# PRODUCT CHANGE NOTIFICATION

PCN-000484

#### Label Changes only

## Appendix A\_1 – Definition of Change and Product Families.

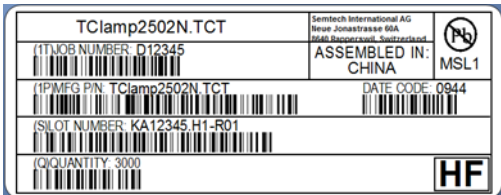
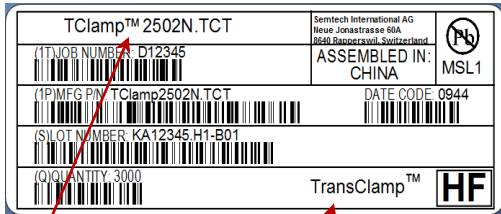
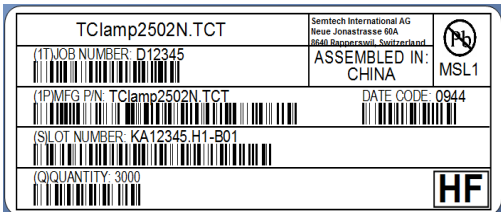
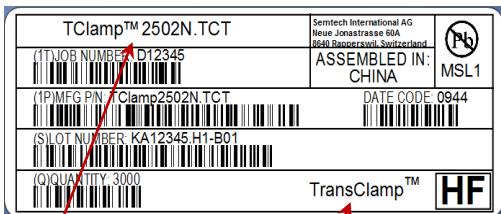
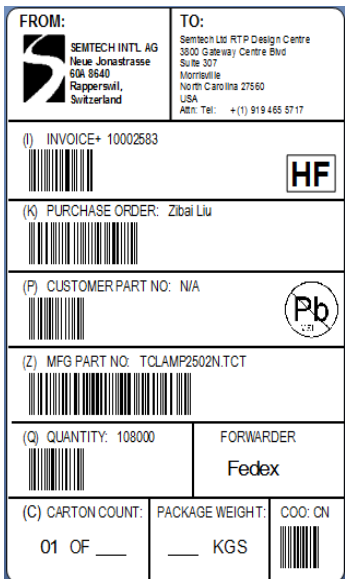
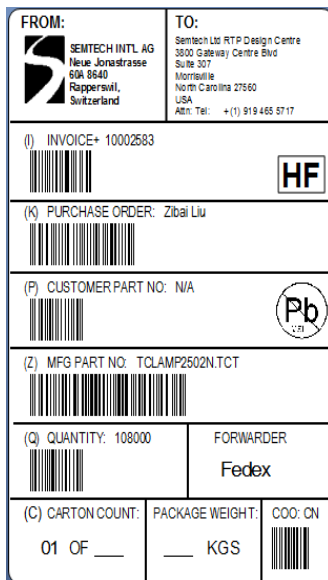
1. Semtech is adding TM/Registered TM & Product Family to the Reel Labels & Inner box labels for Semtech Part Numbers. There is no change to the outer box label.
2. Semtech is removing redundant DC information from Reel Labels and Inner Box Labels. There is no change to the outer box label.

## Appendix A\_2: Example of changes to the full label set

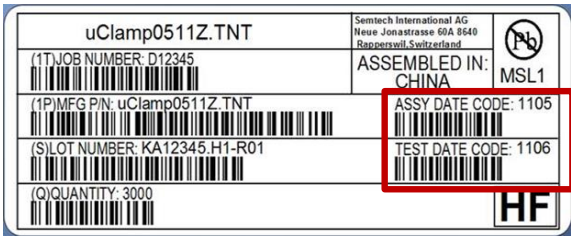
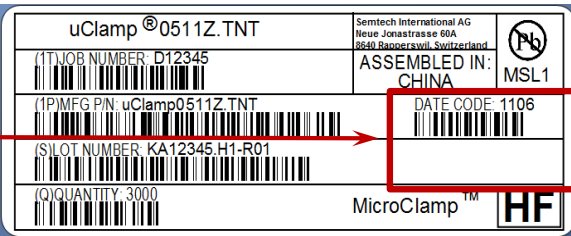
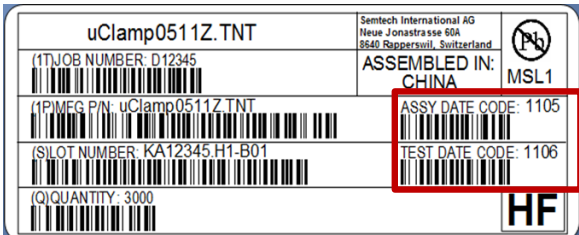
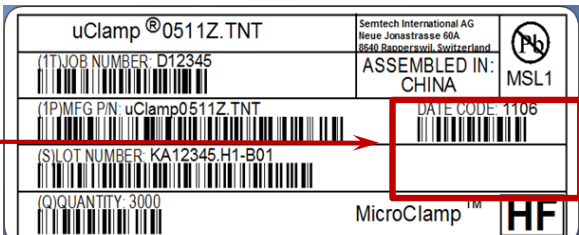
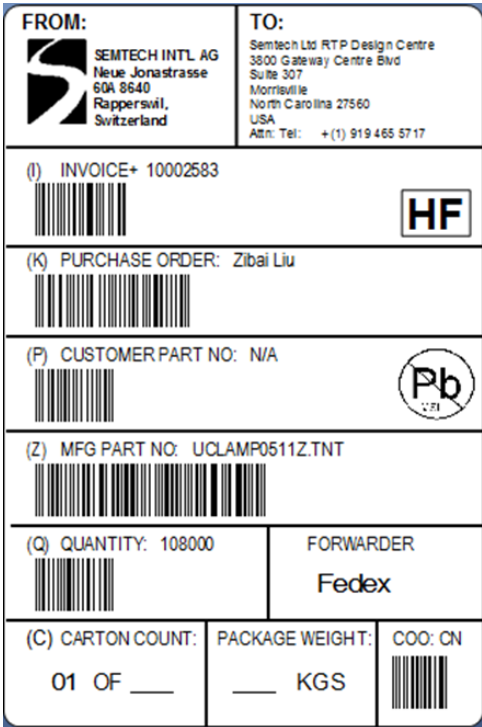
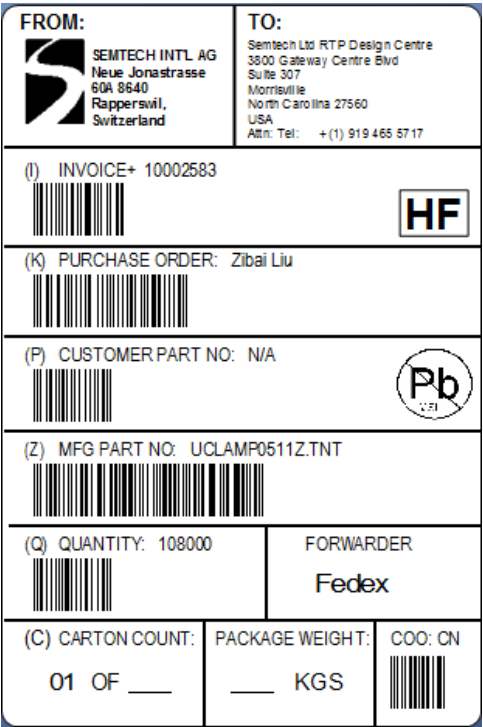
Label Location	Before Change	After Change
Reel	 <p>TClamp2502N.TCT (1) JOB NUMBER: D12345 (1P) MFG P/N: TClamp2502N.TCT (S) LOT NUMBER: KA12345.H1-B01 (Q) QUANTITY: 3000 Semtech International AG Neue Jonastrasse 60A 8640 Rapperswil, Switzerland ASSEMBLED IN: CHINA DATE CODE: 0944 MSL1 HF</p>	 <p>TClamp™ 2502N.TCT (1) JOB NUMBER: D12345 (1P) MFG P/N: TClamp2502N.TCT (S) LOT NUMBER: KA12345.H1-B01 (Q) QUANTITY: 3000 Semtech International AG Neue Jonastrasse 60A 8640 Rapperswil, Switzerland ASSEMBLED IN: CHINA DATE CODE: 0944 MSL1 TransClamp™ HF</p> <p>TM and Product Family Added to Reel Label</p>
Inner Box	 <p>TClamp2502N.TCT (1) JOB NUMBER: D12345 (1P) MFG P/N: TClamp2502N.TCT (S) LOT NUMBER: KA12345.H1-B01 (Q) QUANTITY: 3000 Semtech International AG Neue Jonastrasse 60A 8640 Rapperswil, Switzerland ASSEMBLED IN: CHINA DATE CODE: 0944 MSL1 HF</p>	 <p>TClamp™ 2502N.TCT (1) JOB NUMBER: D12345 (1P) MFG P/N: TClamp2502N.TCT (S) LOT NUMBER: KA12345.H1-B01 (Q) QUANTITY: 3000 Semtech International AG Neue Jonastrasse 60A 8640 Rapperswil, Switzerland ASSEMBLED IN: CHINA DATE CODE: 0944 MSL1 TransClamp™ HF</p> <p>TM and Product Family added to Inner Box Label</p>
